RUSH COUNTY SCHOOL CORPORATION

Rushville Elementary School Renovations

ADDENDUM NO. 1

Date of Issue: May 20th, 2024

**MECHANICAL DEMOLITION FIRST FLOOR
PLAN - UNIT C**

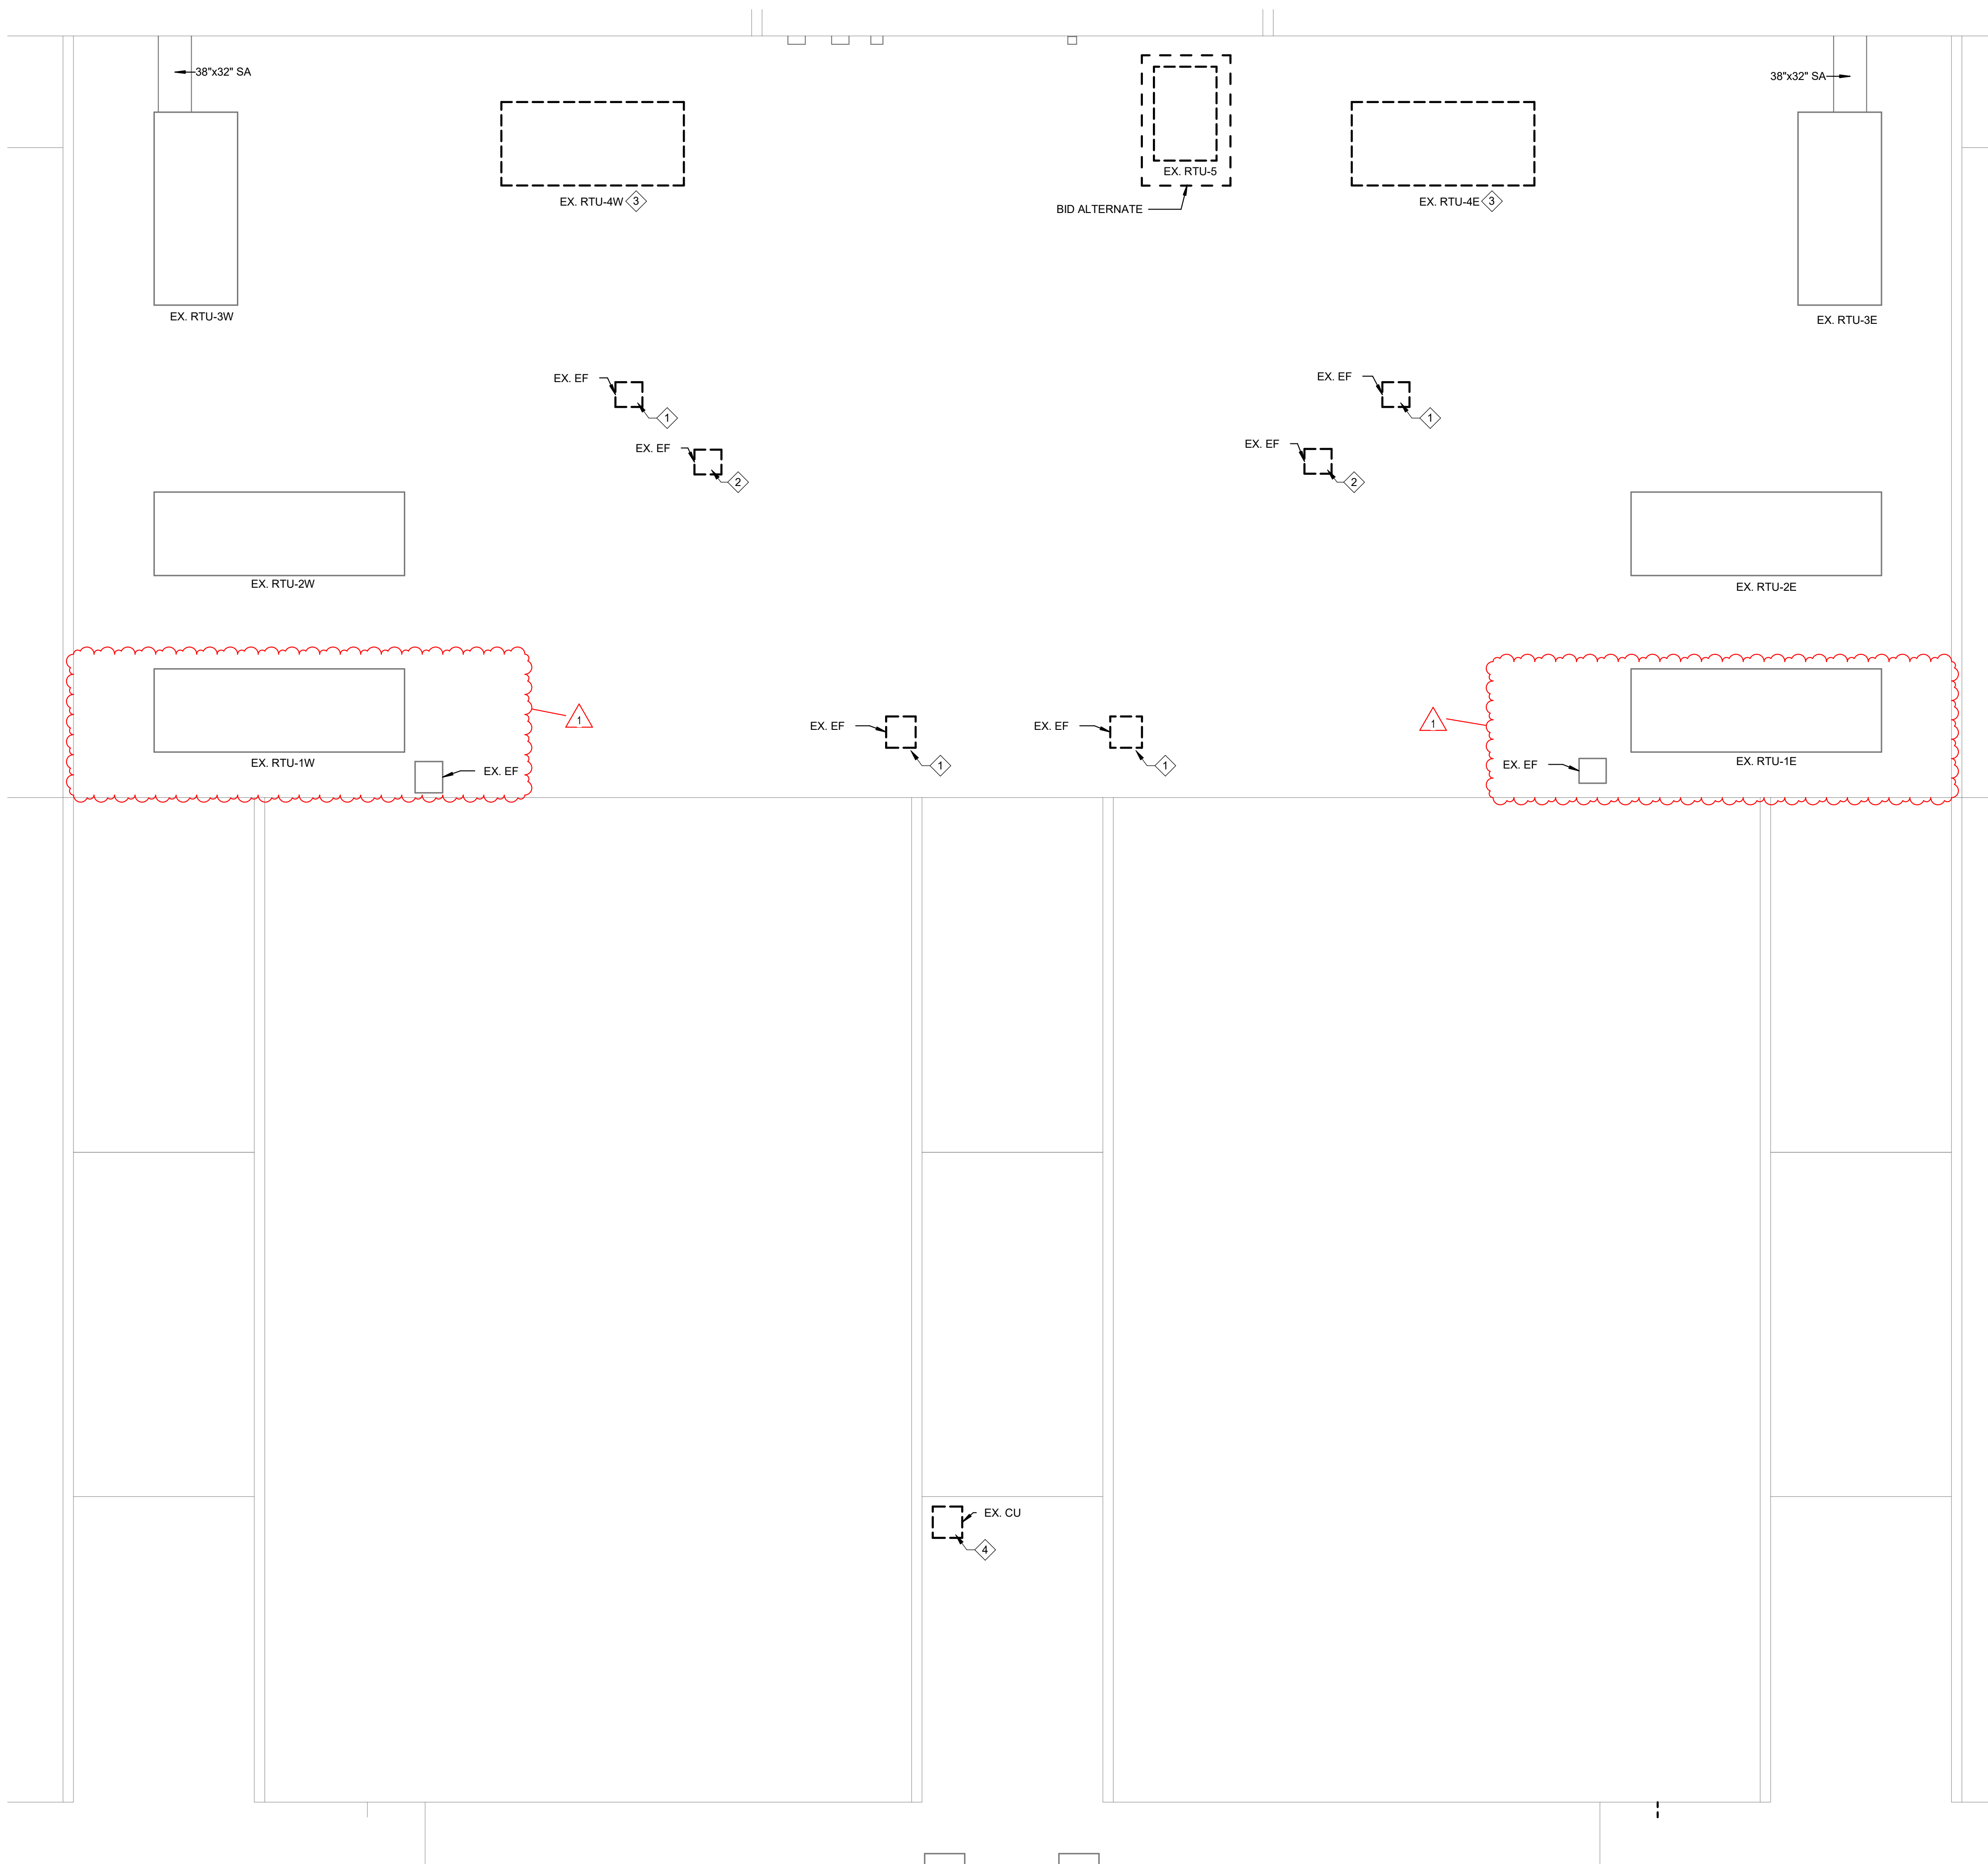
1. REMOVE EXISTING EXHAUST FAN AND PREPARE FOR INSTALLATION OF NEW EXHAUST FAN ON EXISTING CURB. SEE SHEET MR101 FOR NEW WORK.
2. REMOVE EXISTING EXHAUST FAN. SEE SHEET MR101 FOR CURB CAPPING.
3. REMOVE EXISTING RTU AND CURB COMPLETE. SEE MR101 FOR NEW RTU WORK.
4. REMOVE EXISTING CONDENSING UNIT AND PREPARE FOR INSTALLATION OF NEW CONDENSING UNIT.

1 MECHANICAL HVAC FIRST FLOOR PLAN - UNIT B
1/8" = 1'-0"

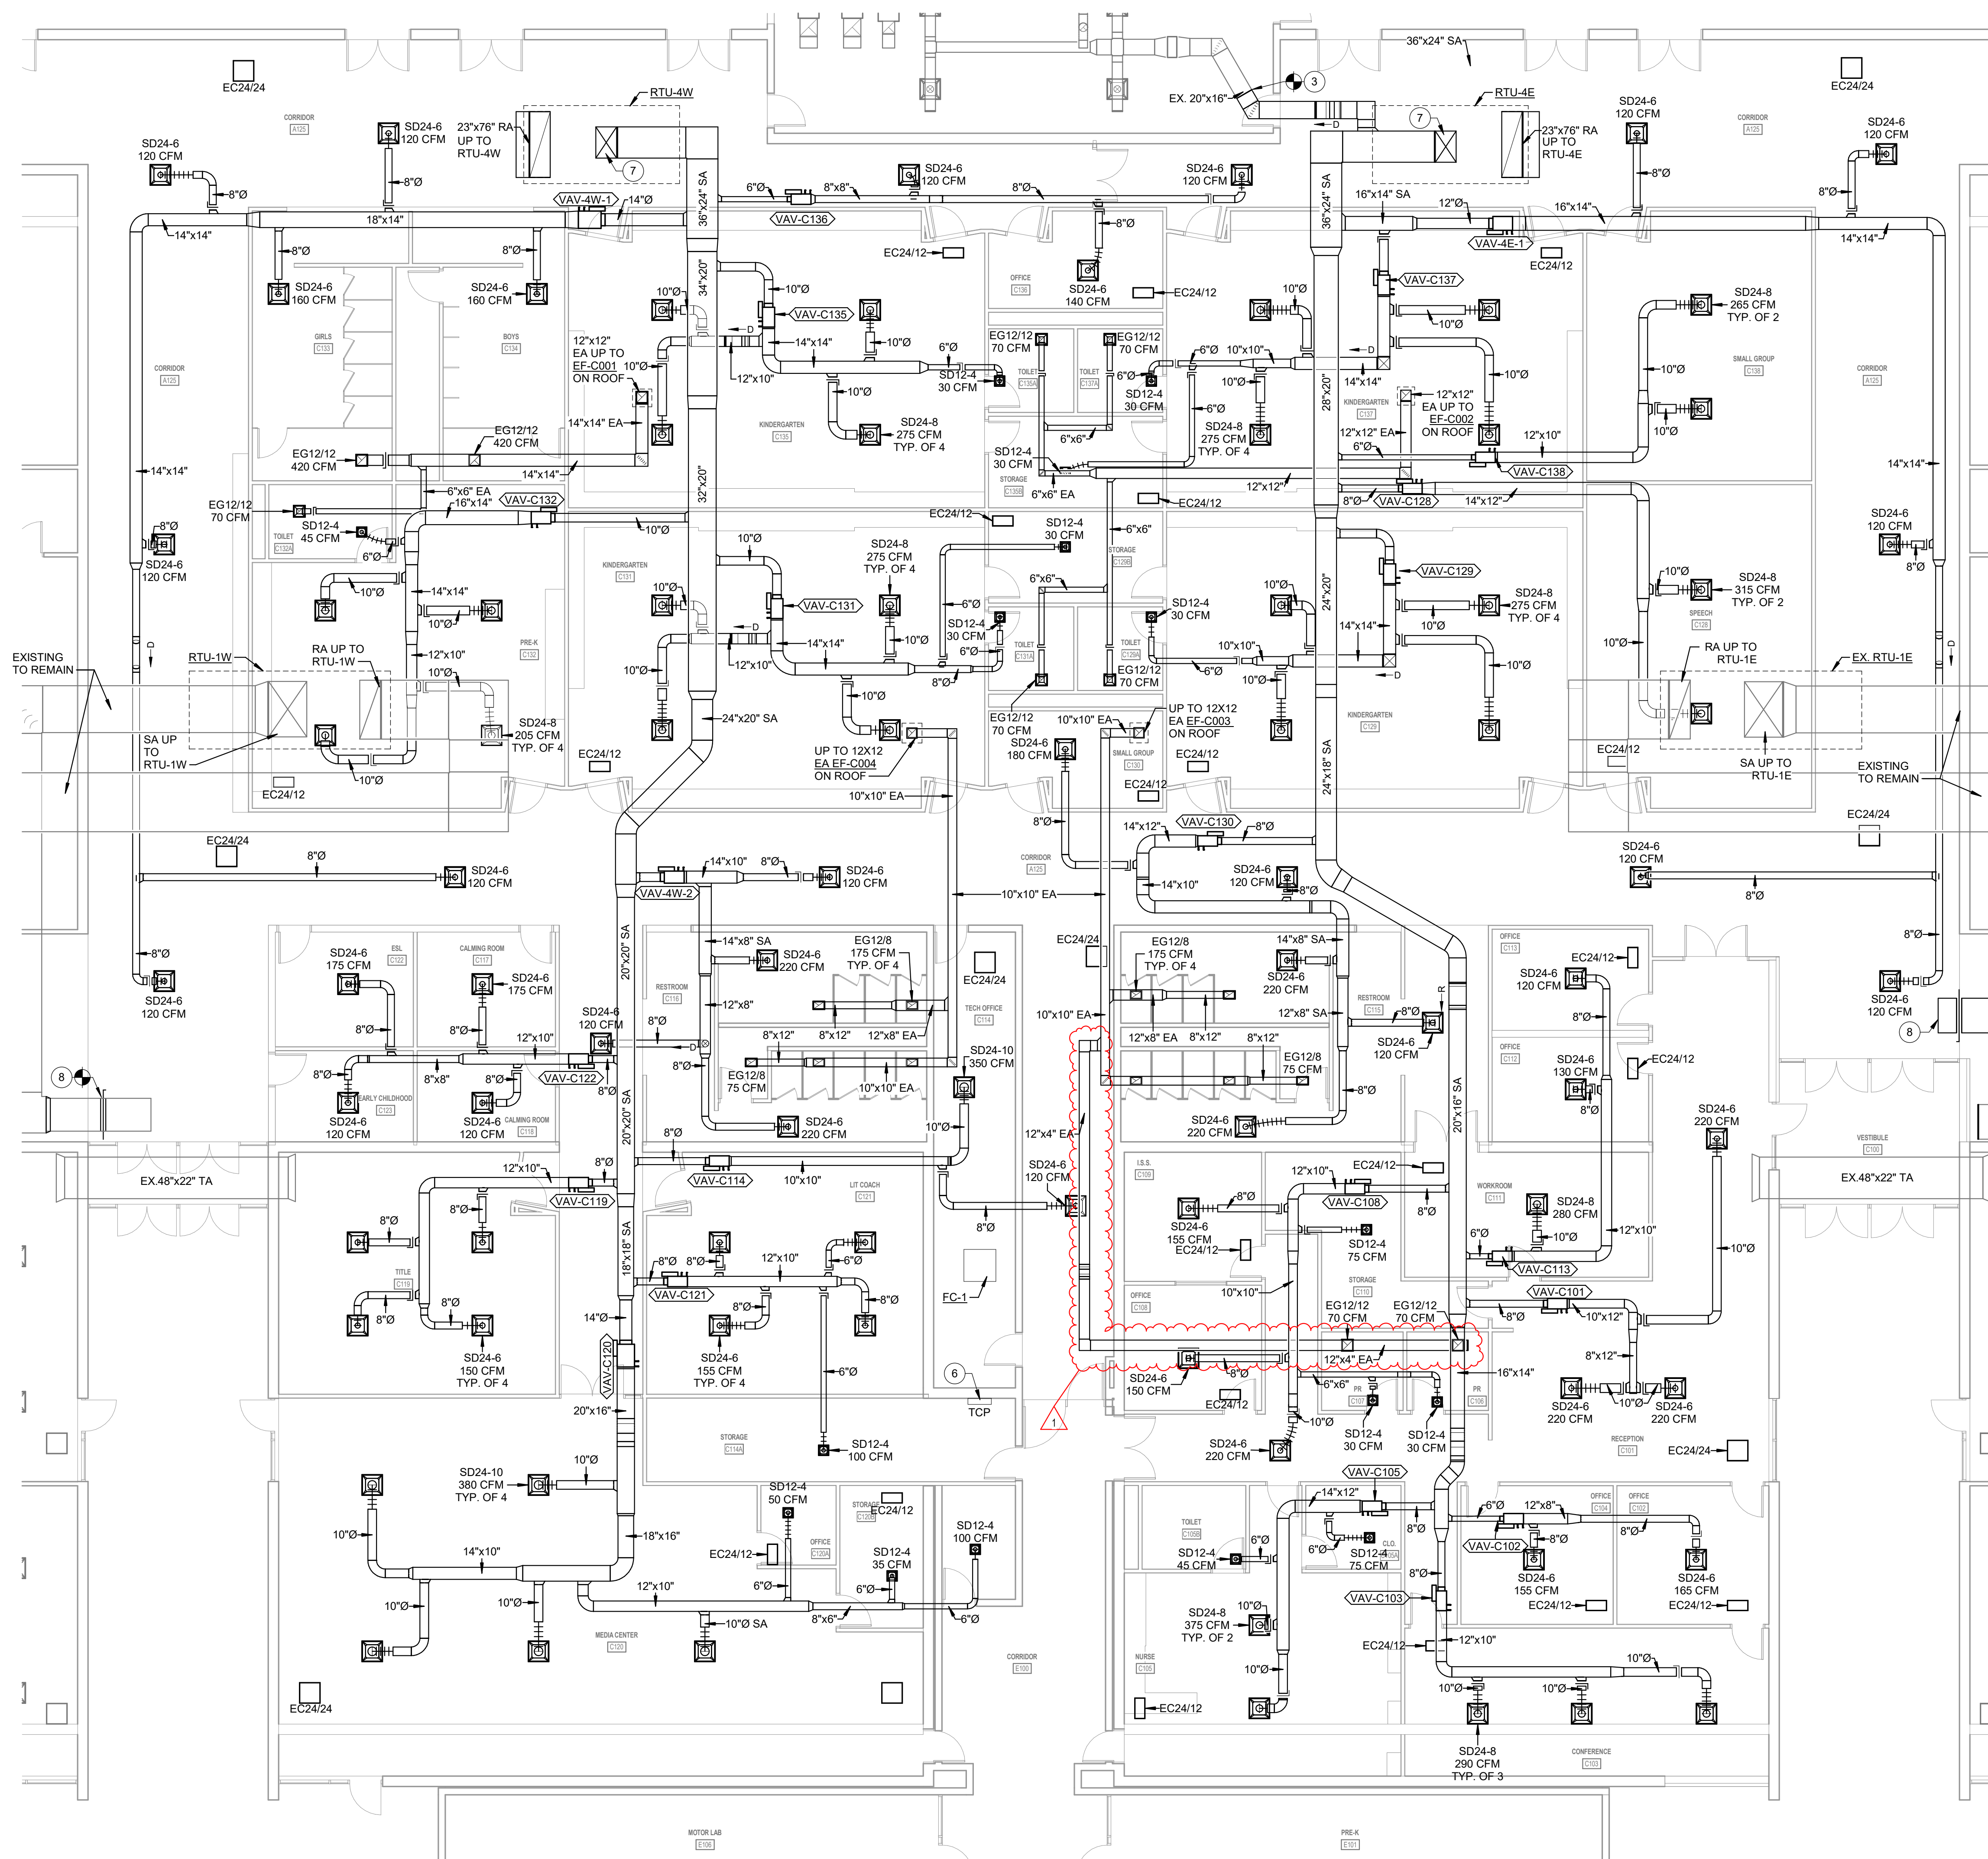
1. PROVIDE CONNECTION TO EXISTING BATHROOM EXHAUST - RE-BALANCE EXHAUST FAN TO PROVIDE EXISTING EXHAUST FLOW RATES IN EXISTING RESTROOMS AS WELL AS ADDITIONAL EXHAUST FLOW FROM NEW RESTROOM. TAKE READINGS AND DOCUMENT EXISTING EXHAUST FLOW FROM RESTROOMS PRIOR TO BEGINNING WORK.
2. PROVIDE BACKDRIFT DAMPER AND BIRD SCREEN WITH WALL CAP.
3. CONNECT SINGLE WALL GALVANIZED STEEL SHEET METAL DUCT TO EXISTING INTERIOR LINED GALVANIZED STEEL SHEET METAL DUCT. REFER TO DETAIL 10.01 ON SHEET M-501.
4. REBALANCE EXISTING DIFFUSER/GRILLE TO VALUE DETERMINED AT TIME OF AIRFLOW READINGS PRIOR TO DEMOLITION.
5. TCC SHALL COORDINATE WITH MC AND EC FOR FINAL LOCATION.
6. 36x24 UP TO RITS SUPPLY CONNECTION. TRANSITION TO UNIT OPENING.
7. RE-BALANCE EXHAUST FLOW RATES DETERMINED AT TIME OF READINGS PRIOR TO DEMOLITION MINUS 73% CFM.

1 MECHANICAL PIPING FIRST FLOOR PLAN - UNIT C
1/8" = 1'-0"

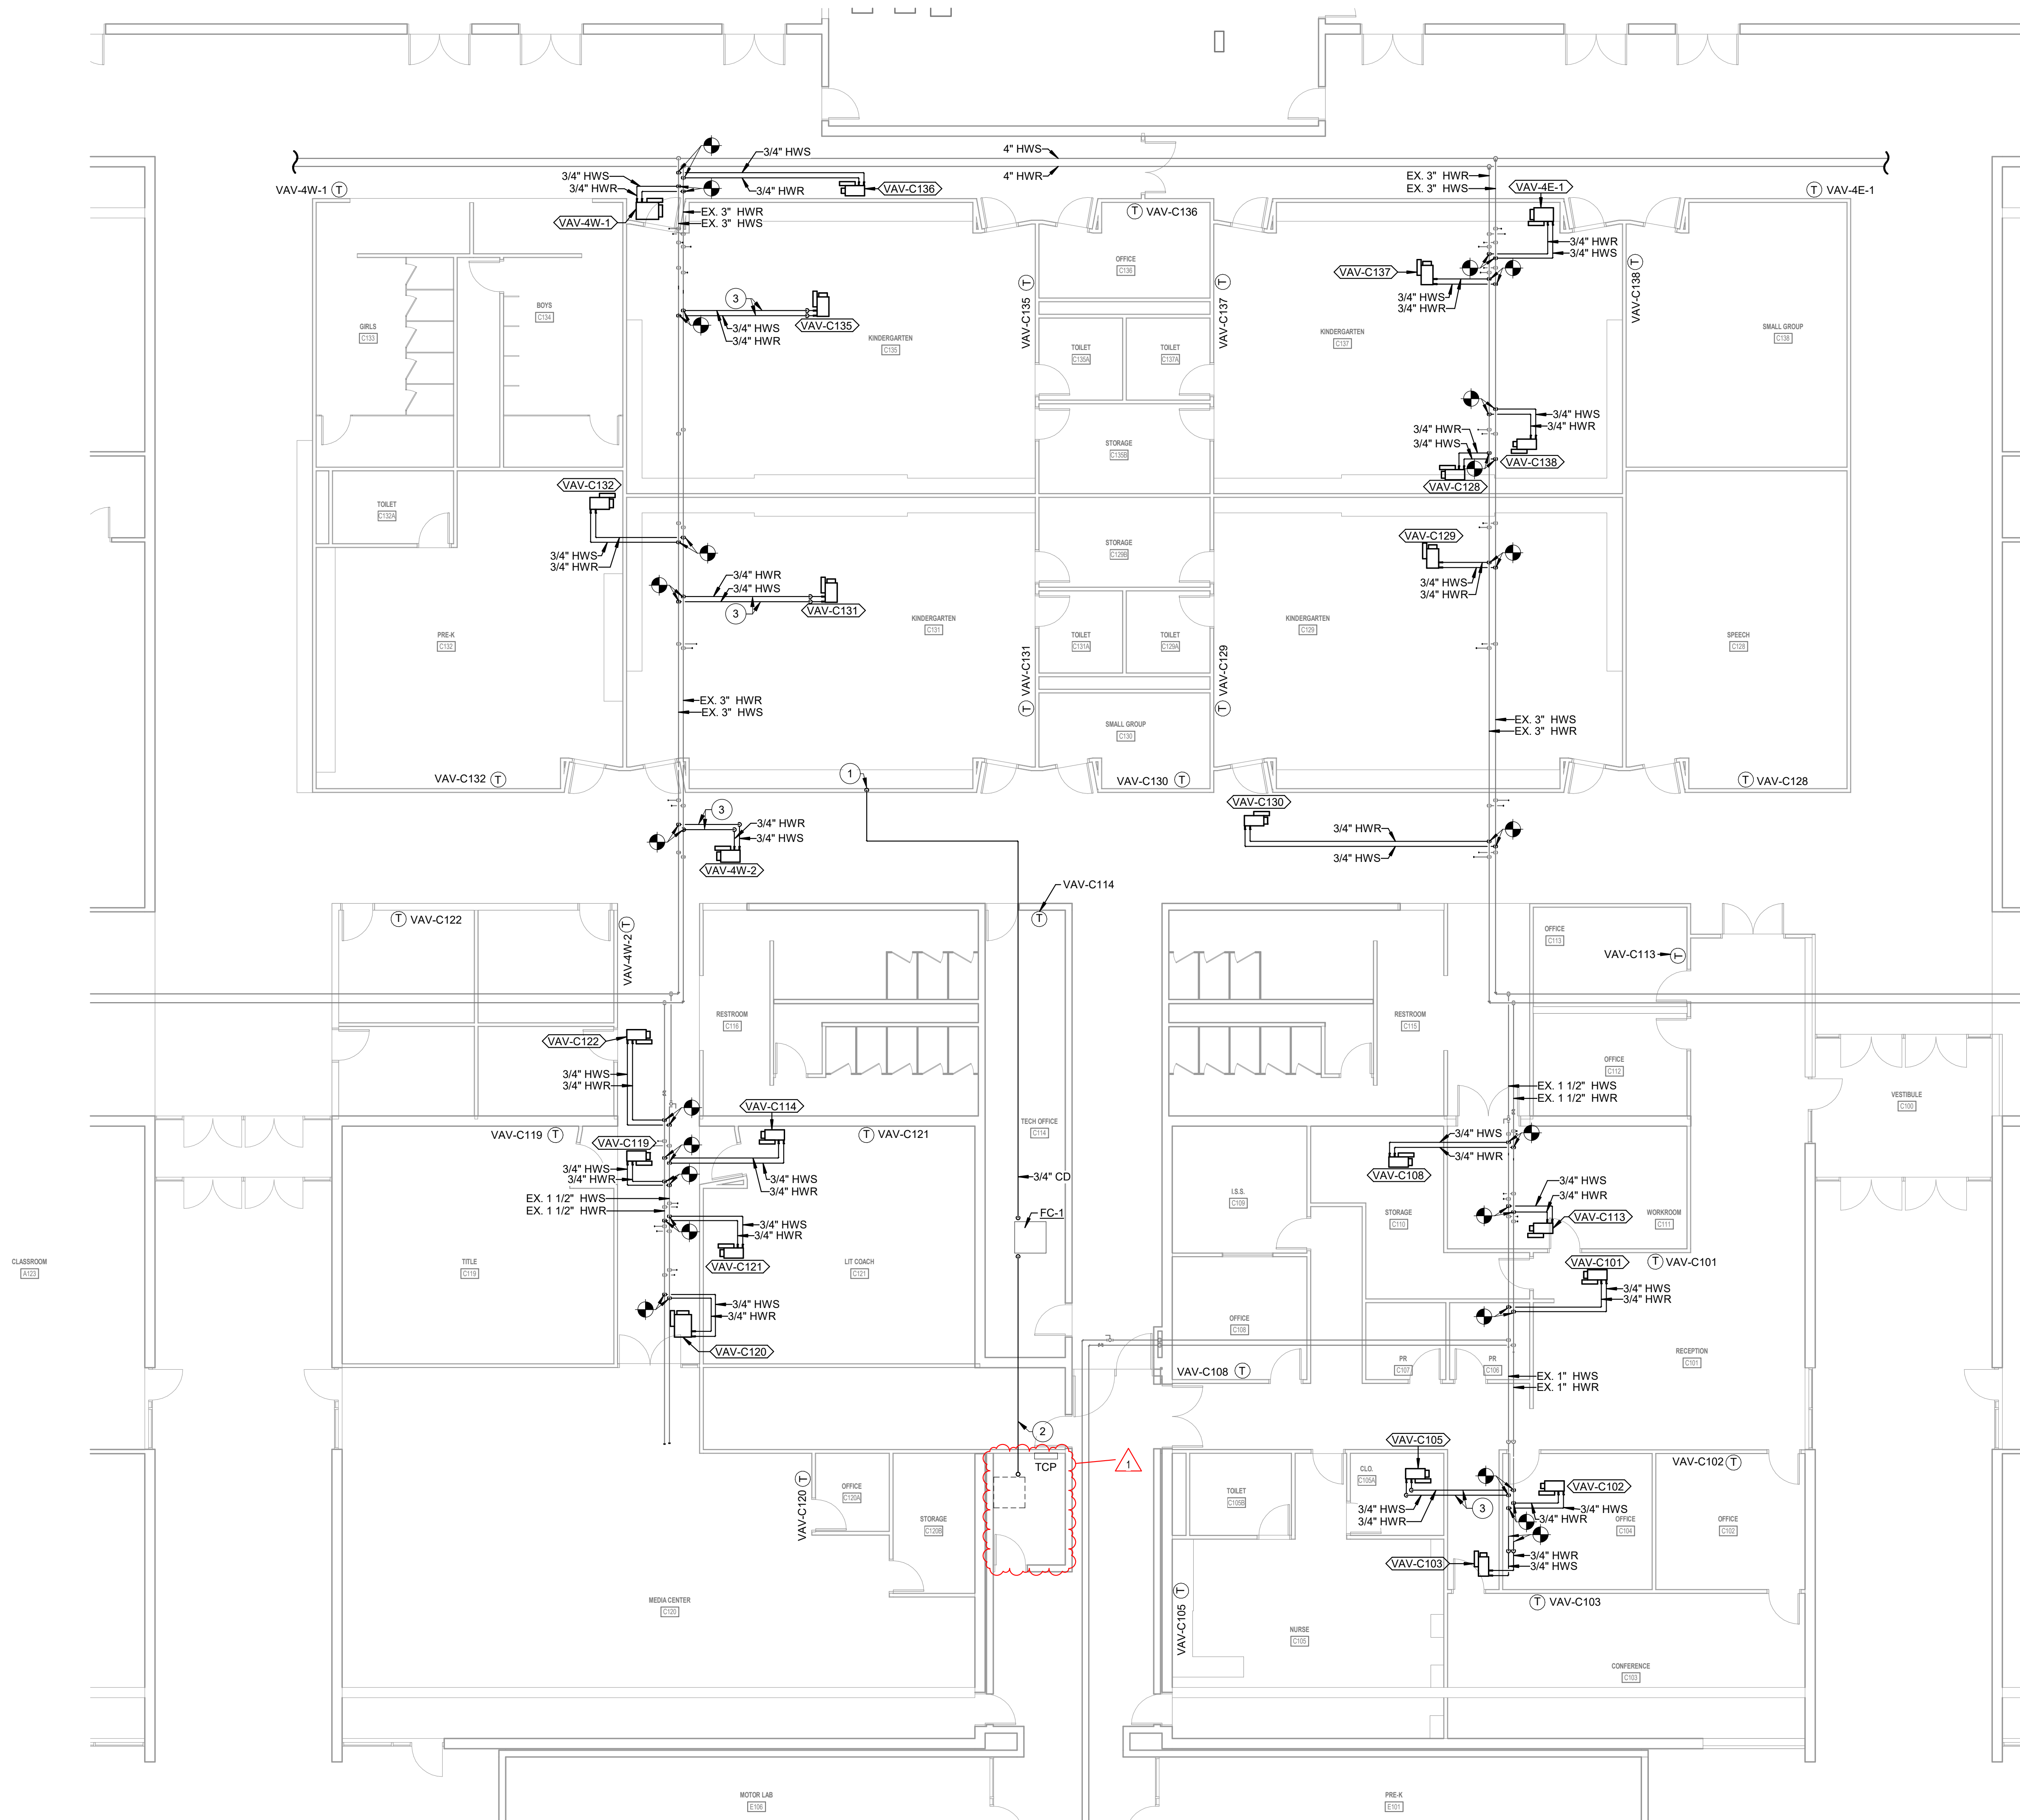
1. ROUTE CONDENSATE DOWN IN NEW WALL TO AUXILIARY TAILPIECE CONNECTION AT SINK DRAIN.
2. INSTALL NEW REFRIGERANT PIPING FROM FAN COIL TO CONDENSING UNIT. INSULATE ALL REFRIGERANT LINES. SIZE PIPING PER MANUFACTURERS RECOMMENDATION BASED ON TOTAL EQUIVALENT LENGTH.
3. ROUTE ABOVE SUPPLY MAIN DUCT.
